## FIELD OBSERVATION REPORT

Lincoln Trail Elementary School, Hardin County Schools, Elizabethtown, KY 201752 -CA8

Report No: 34

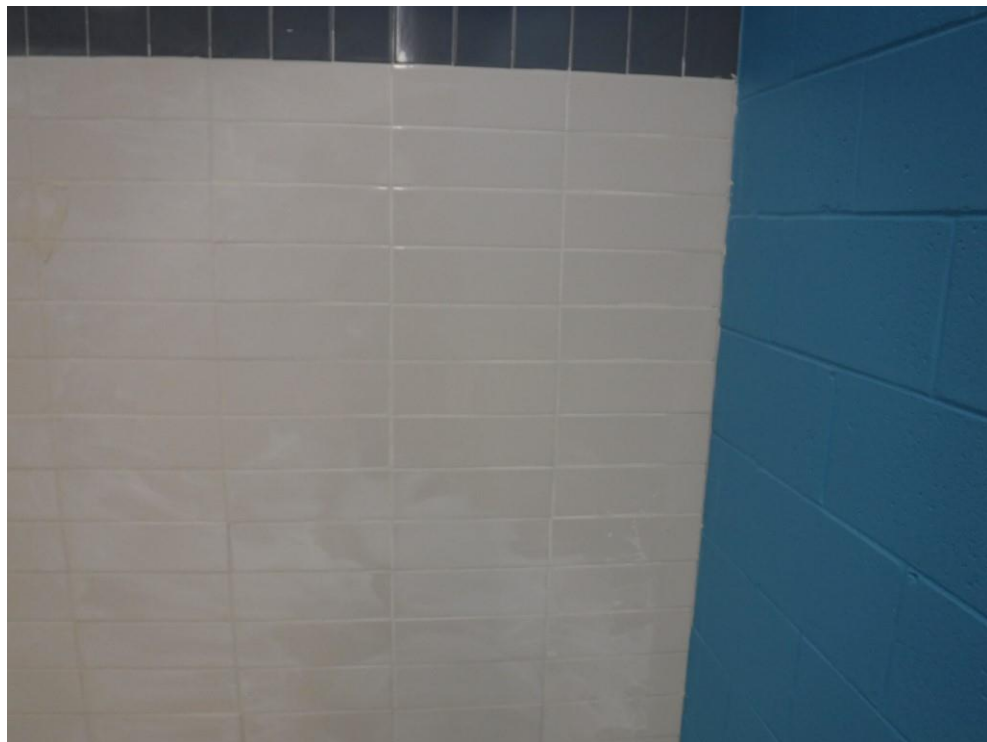
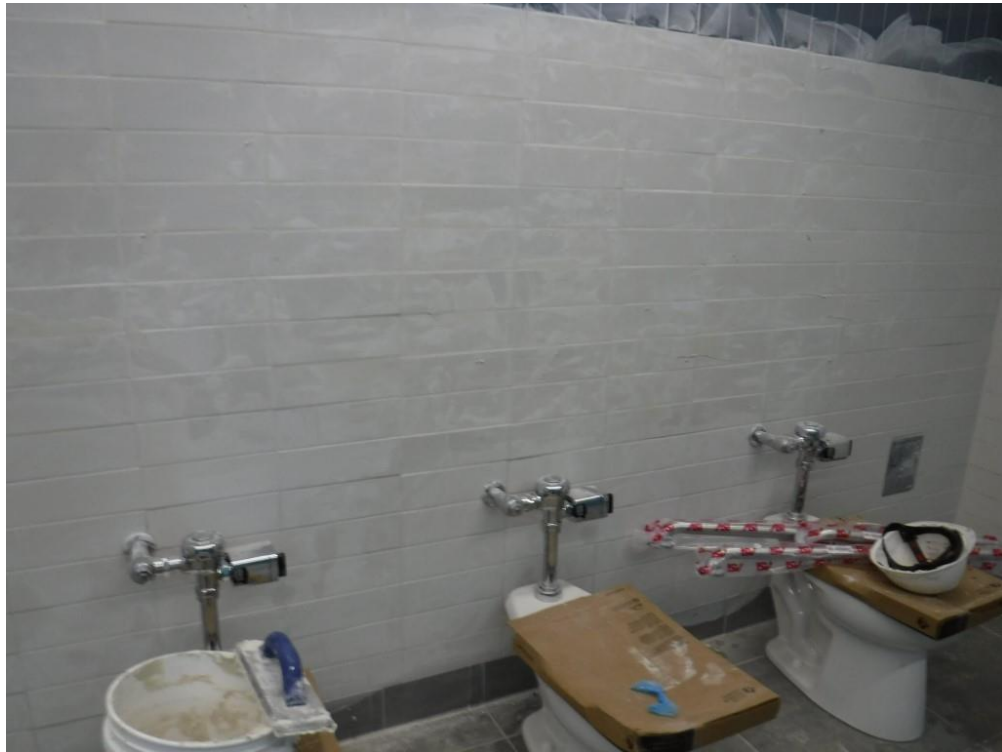
We met with representatives of Edgar Belle and Dixie Exteriors to examine the samples for the trim around the windows at the fiber cement panels. The metal matches the window frames. They were installing the trim angle with a 1" wide leg showing on the face of the panels. The trim must be fully adhered to the insulation stop in the wall and be fully adhered to the fiber cement panels. The exposed flashing along the counterflashing also needs to be covered with panels.

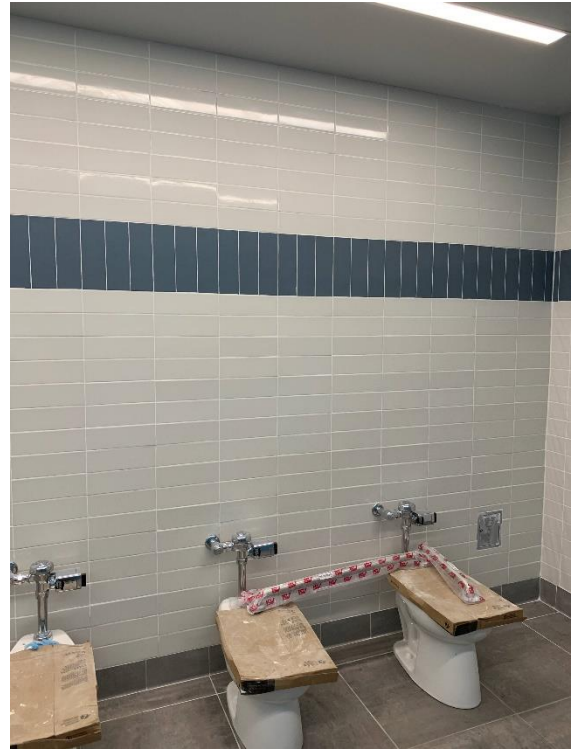
- b) The wall tile on the fixture wall in one of the toilet groups had been regouted by the installer. On the lower image, a small section on the end wall was cleaned to reveal a sample of what this might do to the appearance of the tile. We agreed that the sample was acceptable and we would examine the joints again the next day.

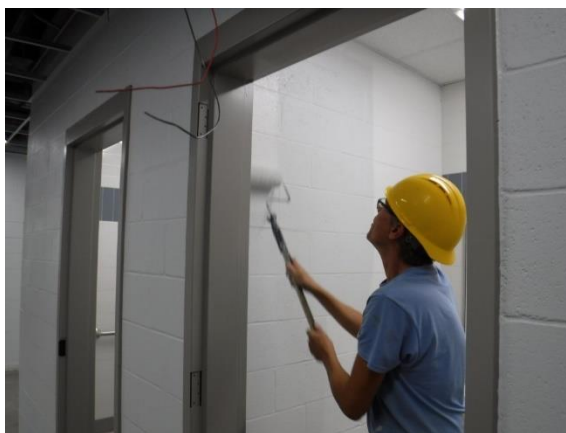
- j) There are many open caulk joints. Unfortunately, the caulking in the joint over the main entry is smeared on the block. This must be corrected as is the case for all joints like this one.

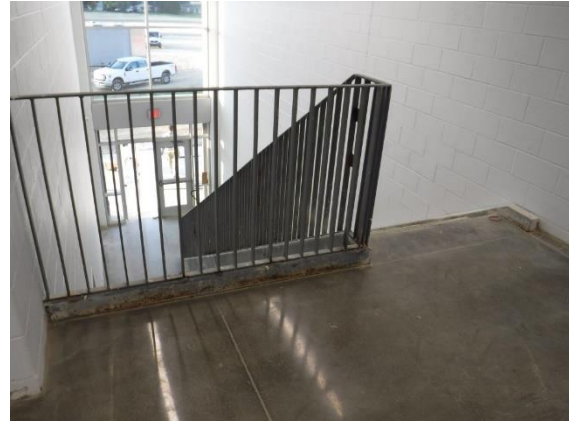
- p) Final detailing of the welds on the stairs must be done before they can be painted.

- q) Welds on the railings were ground, but primer was not applied.

- r) A large glob of mortar is still at the bottom of the wall at the toilet group in Area B.

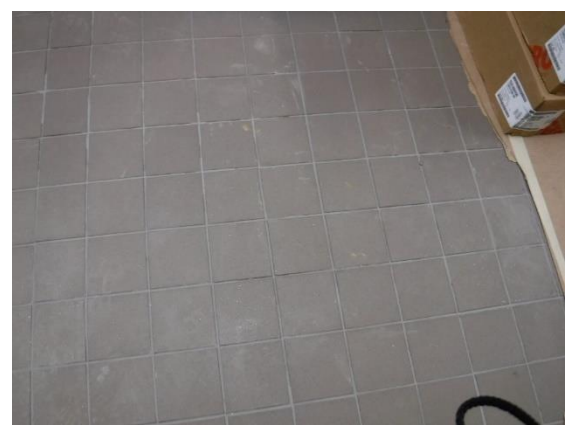
- u) The bent plates at the steel frame do not close to the columns. This must be corrected to avoid having a place where birds and insects can enter the soffit at the canopy.

- v) The cooler/freezer wall was damaged during installation. This must be replaced.

- w) The epoxy grout joints in the Kitchen floor are not completely filled. This must be corrected.

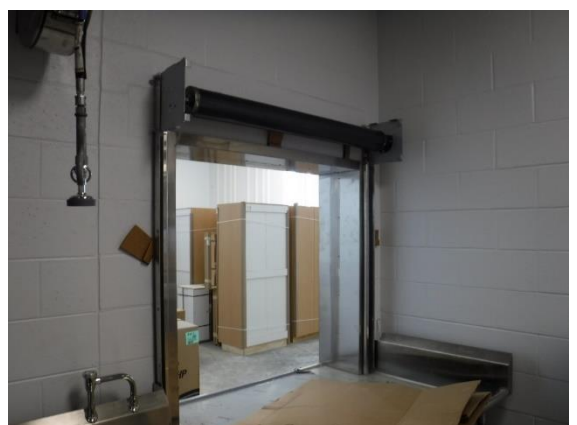
- x) The fire curtain at the dish return is missing parts.

- y) When the sun passes a certain point, it reveals uneven textures in the fiber cement panels. This appears to be all in the panels and not the installation.

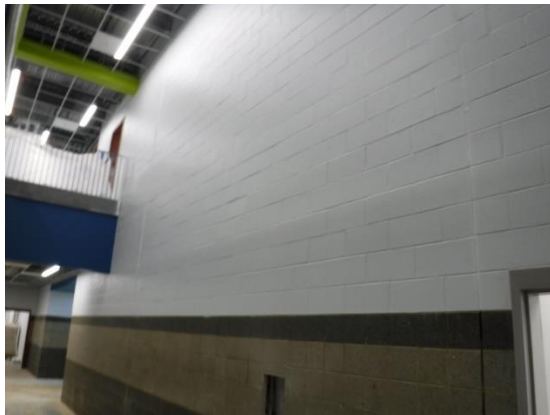
- z) The concrete block on the two-story wall in the main lobby is especially rough. This must be corrected.

- aa) The 1" aluminum trim around the windows in the fiber cement panels was reviewed. We found this to be acceptable.

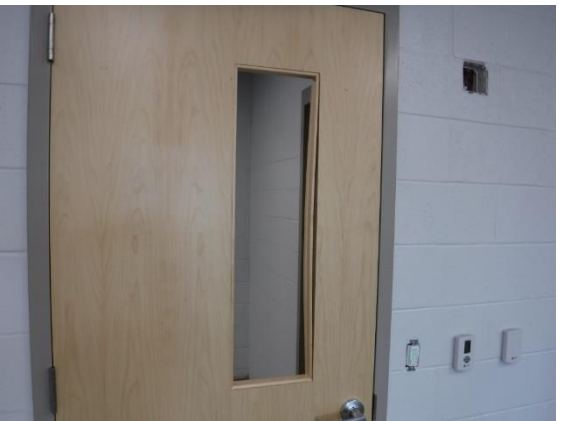
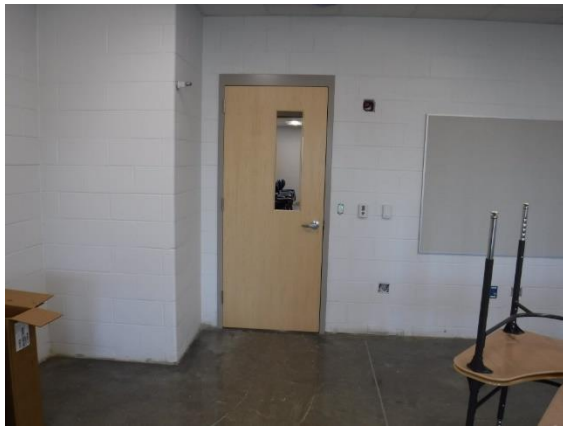
- bb) Care needs to be taken to provide square corners in the trim.

- cc) The wood doors were being hung. Unfortunately, this had to be done before the hollow metal frames were repaired and repainted. Repair work to the frames must not damage the doors.
